## Parts & Service Bulletin

Model: All With Transmission-Mount PTO

Subject: **PTO Replacement – Best Practices**

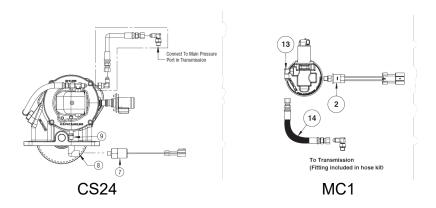
In the event that a discontinued model must be replaced by a newer series PTO please note that aspects of the installation may vary slightly, while generally the new PTO will be fit and function compatible- this installation will be detailed in an instruction booklet. For instance, below and on the left is shown a typical installation for a now-discontinued CS24 model PTO. On the right we have shown a typical installation for a replacement A20 series PTO. As you can see there are multiple differences between the two:

- The solenoid housing is of a different design.
- The transmission pressure line routing is different.
- The pressure switch installation location is also different.

These installation differences are minor but must be respected or the new PTO may not function properly or could experience damage. To outline and explain any of these differences all PTOs ship with the previously mentioned installation booklet as well as an installation kit-please follow these instructions and make use of the new kit of parts. If for any reason this guide and kit are not received, please reach out to Labrieplus with any questions.
